**Request for Additional Information No. 82
(1082, 1096, 1107, 1113, 1125, 1151, 1098, 1097), Supplement 4**

U. S. EPR Standard Design Certification

**SRP Section: 06.02.01.05 - Minimum Containment Pressure Analysis for
Emergency Core Cooling System Performance Capability Studies**

Question 06.02.01.05-1:

Figure 06.02.01.05-1a-1—U.S. EPR Containment Pressure Comparison with Different Heat Transfer Coefficients

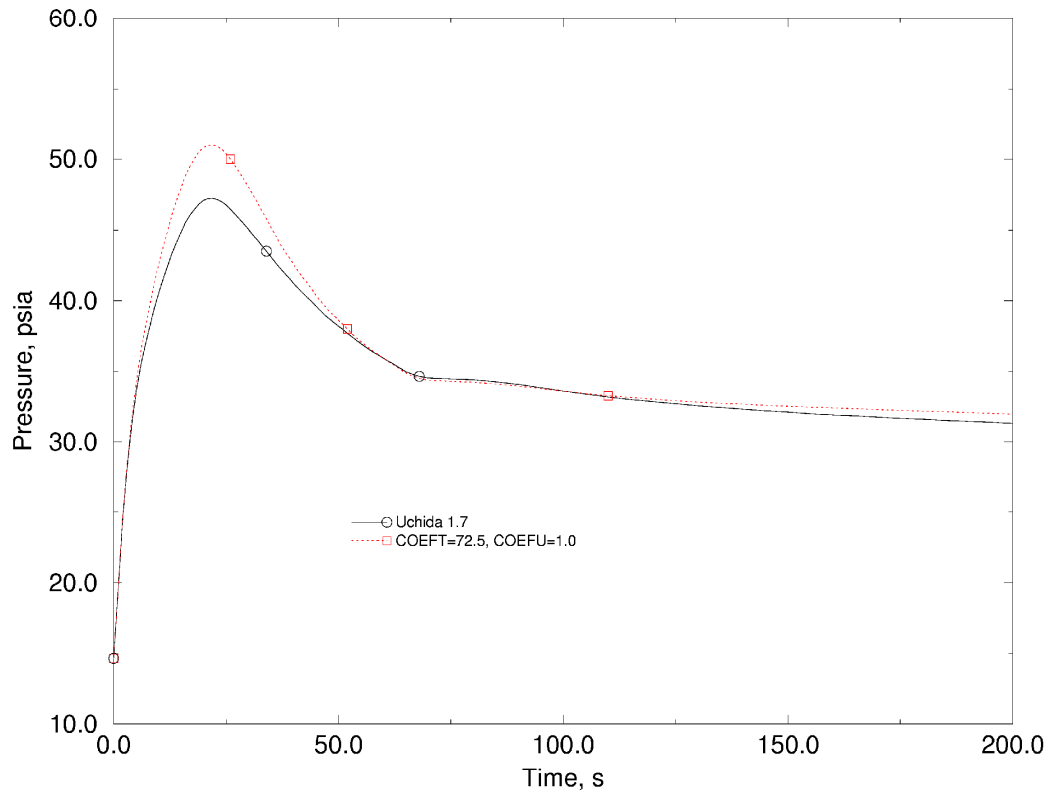
- a. Instead of the conservative heat transfer coefficients recommended by BTP 6-2 the minimum containment pressure analysis for the US-EPR realistic LOCA used heat transfer coefficients that were 1.7 times the Uchida correlation which were benchmarked against 1.0 times the Tagami correlation and then 1.2 times the Uchida correlation. These were described as best estimate. Provide: 1. Justification that the heat transfer correlations selected for the EPR minimum containment pressure analysis are indeed best estimate and 2. Provide the basis for the uncertainty in these coefficients so that these uncertainties may be applied in the realistic LOCA calculations.

AREVA NP compared the containment pressure response using 1.0 x Tagami plus 1.0 x Uchida, and then 1.7 x Uchida alone. For the U.S. EPR, Figure 06.02.01.05-1a-1 shows that using the 1.7 x Uchida correlation for condensation heat transfer produces a lower containment pressure than 1.0 x Tagami (COEFT = 72.5 in the figure) plus 1.0 x Uchida (COEFU = 1.0).

Figure 06.02.01.05-1h-1—U.S. EPR ICECON Containment Model

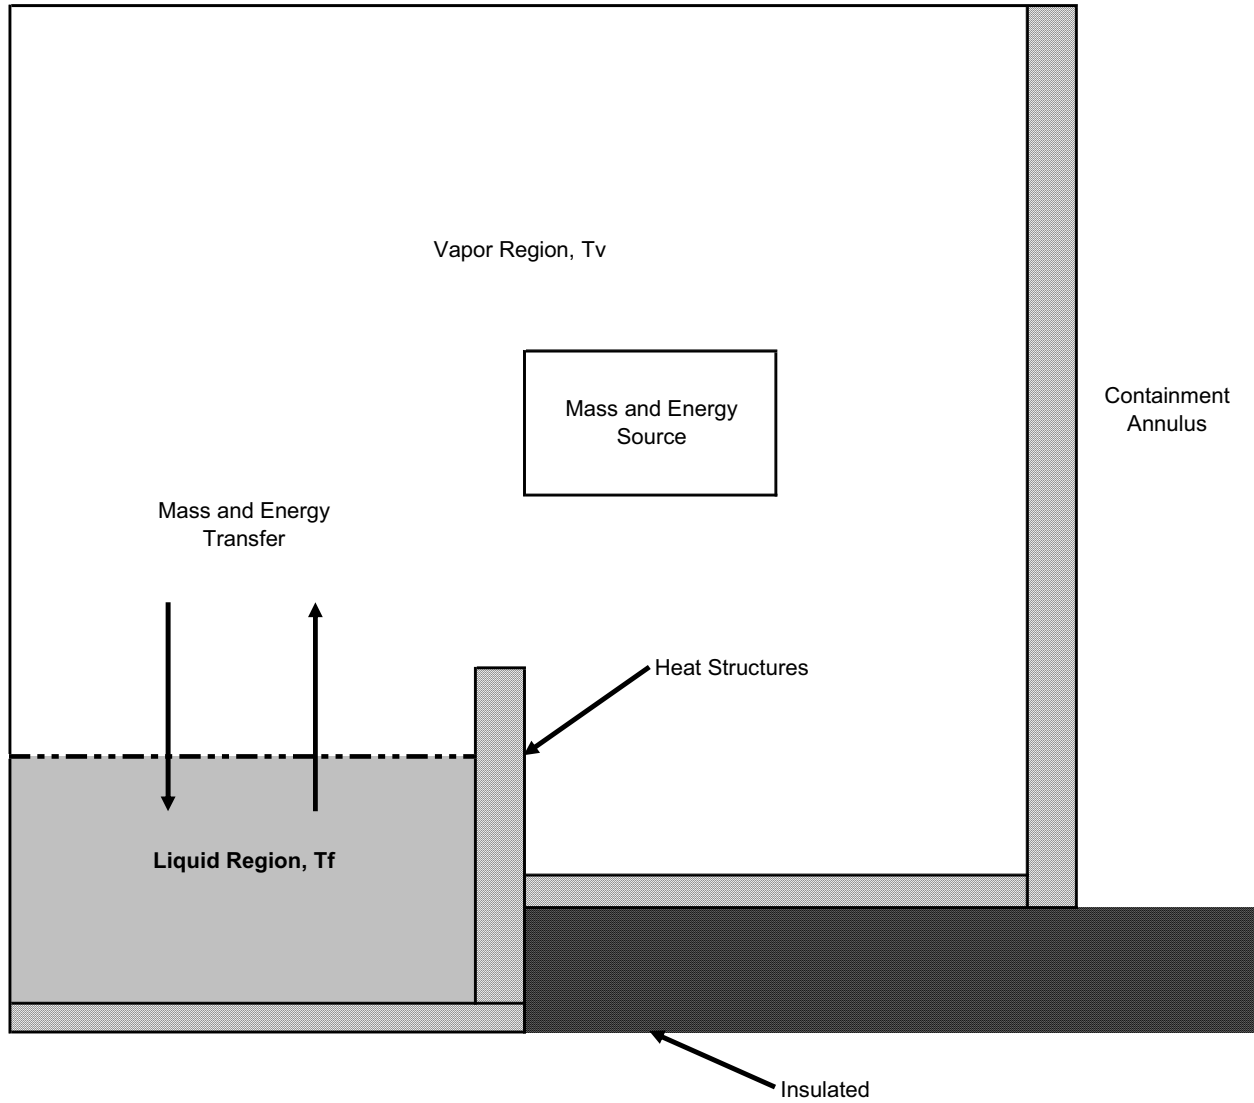
- h. Minimum containment pressure is calculated by the ICECON module embedded in S-RELAP5. Provide a noding diagram of the ICECON containment model and justify that the noding is conservative for calculating minimum containment pressure. In a presentation to the NRC staff January 29, 2008, Areva presented a sensitivity study showing that a multi-node GOTHIC model of the EPR produced containment pressure several psi lower than the single node model. Perform a similar noding sensitivity study using ICECON to show that noding detail is being conservatively accounted for.

Figure 06.02.01.05-1h-1 is a schematic of the U.S. EPR ICECON containment model showing the reactor vessel and containment volumes. The reactor vessel and primary system are represented as a mass and energy source to the containment volume. The containment building is modeled as being in contact with the containment annulus on the exterior side.
